# PINNACLE AT TARPON RIVER

## **DEVELOPMENT REVIEW COMMITTEE (DRC) COMMENT REPORT**

**Case Number: 36R13**

**Request: Site Plan Review / One Hundred Twelve Multi-Family Units**

A-6.0

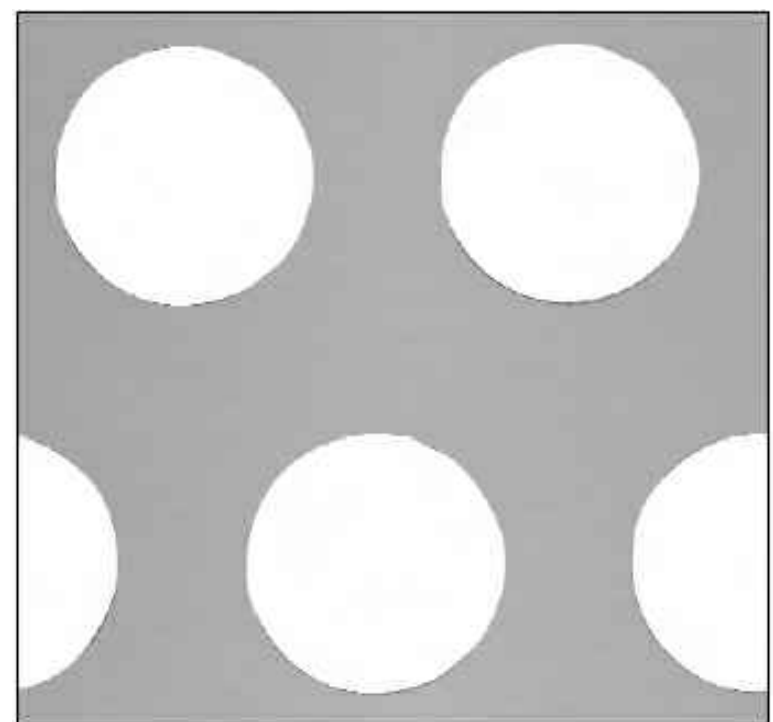
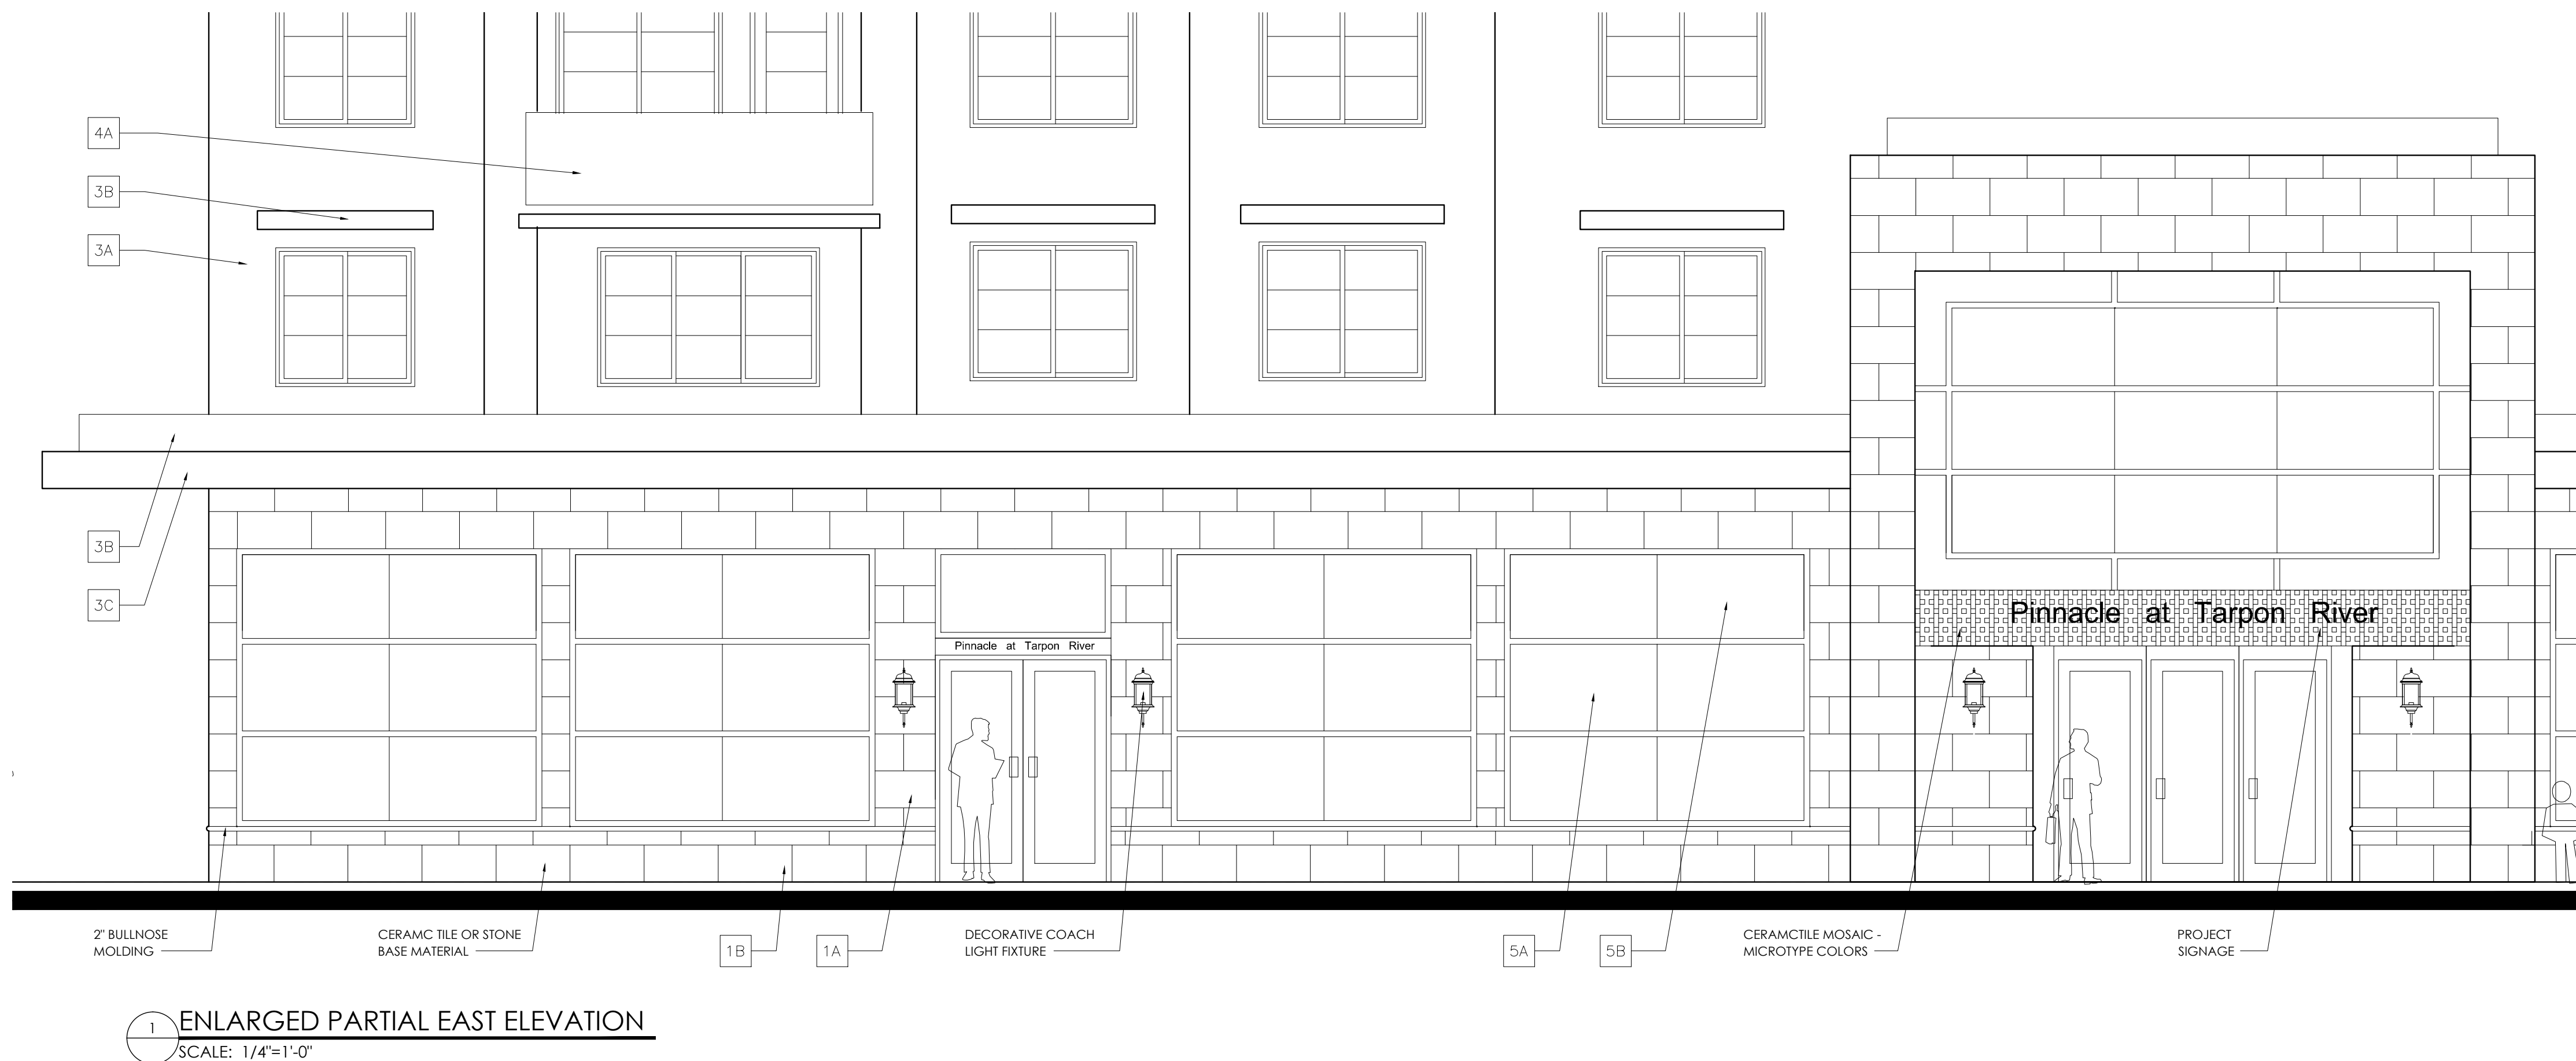
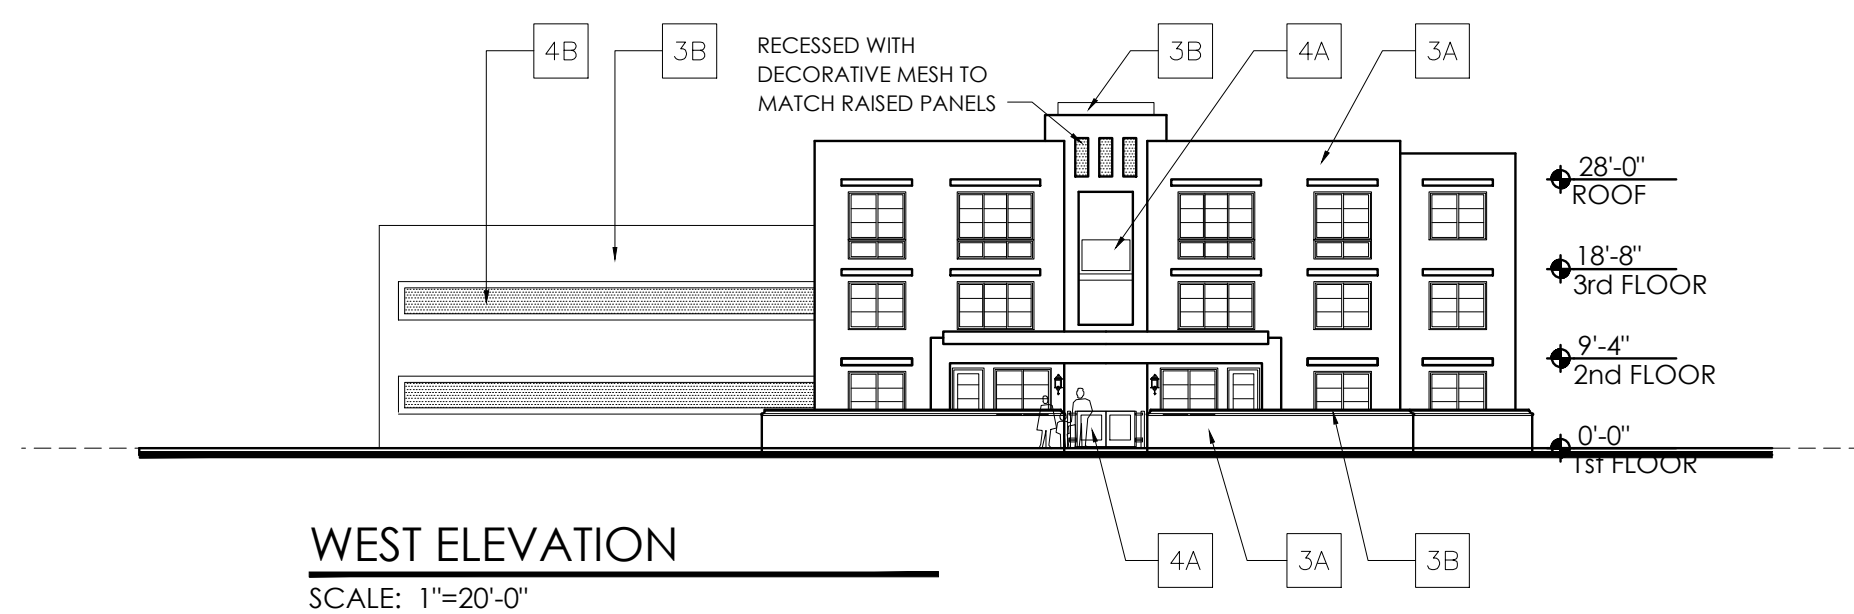
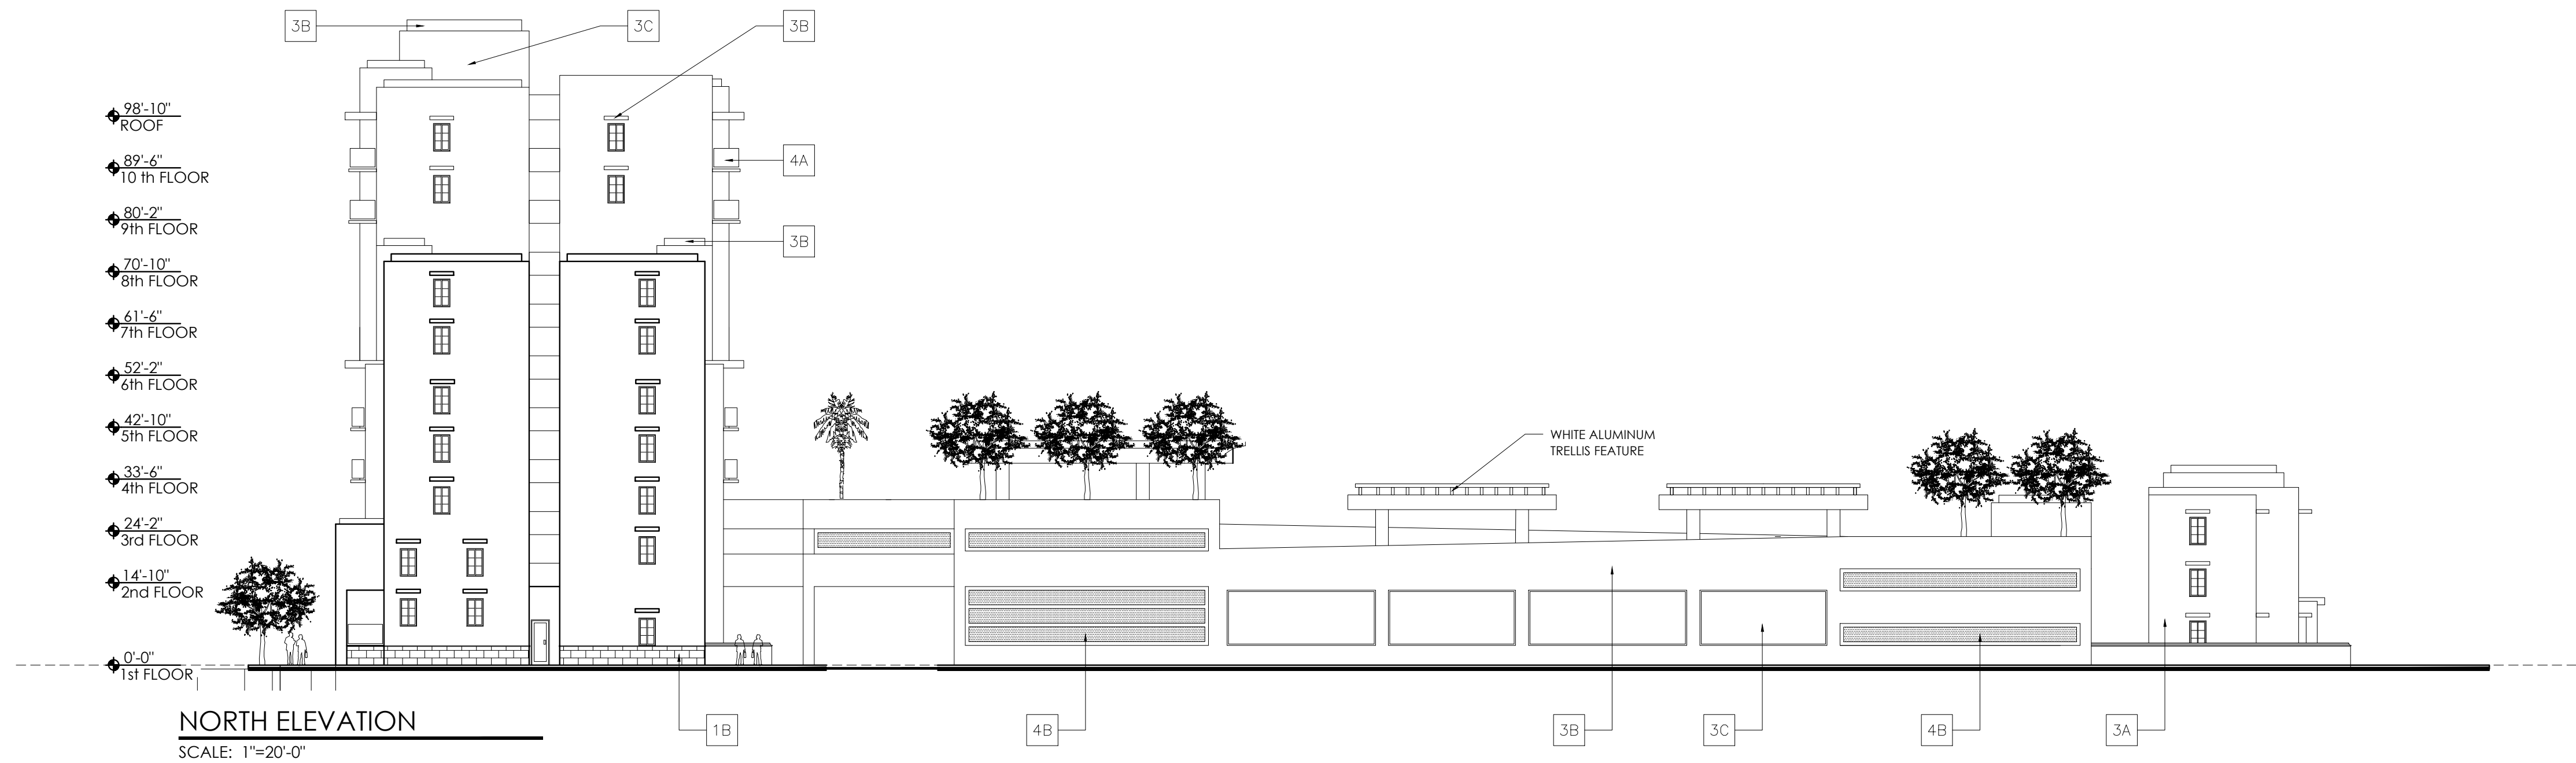
5. Revise the site plan to reflect the following alteration so that adequate sight visibility and safe and non-conflicting egress from the development and surrounding street intersections are implemented.

- a. Relocate the on-street parking spaces along SE 8<sup>th</sup> and SE 9<sup>th</sup> Streets immediately to the west of the intersection of the said streets and SE 3<sup>rd</sup> Avenue to a distance of 20 feet to the west of the proposed location.

- b. Remove the on-street parking space along SE 9<sup>th</sup> Street, immediately to the east of the intersection of the said Street with SE 2<sup>nd</sup> Avenue.

6. Discuss the proposed on-street parallel parking spaces along SE 3<sup>rd</sup> Avenue with the Broward County Highway Construction and Engineering.
7. Show the typical angle for angled parking spaces along with all relevant dimensions for the aisles, ramp slope, pavement radii, etc on the site plan.

8. Show sight triangle for the egresses. According to ULDR, the sight triangle is a triangular shaped portion of land established for unobstructed visibility of motorists entering or leaving a street or driveway intersection in which nothing, whether stationary or moveable (i.e., vehicles, vehicular maneuvering area, signs, landscaping or objects of any kind) is permitted to be located between a height of two and one-half (2½) and eight (8) feet above the adjoining edge of pavement. The sight triangle is measured ten (10) feet from the intersection point of the edge of pavement and the driveway.

11. Provide typical cross sections and section profiles along all property lines. Also show how the existing and proposed grades will tie to one another.

12. Show spot elevations along the perimeter (property lines) on the paving and grading plan.
13. Show utilities on the lighting and landscaping plans for potential conflict with the design.
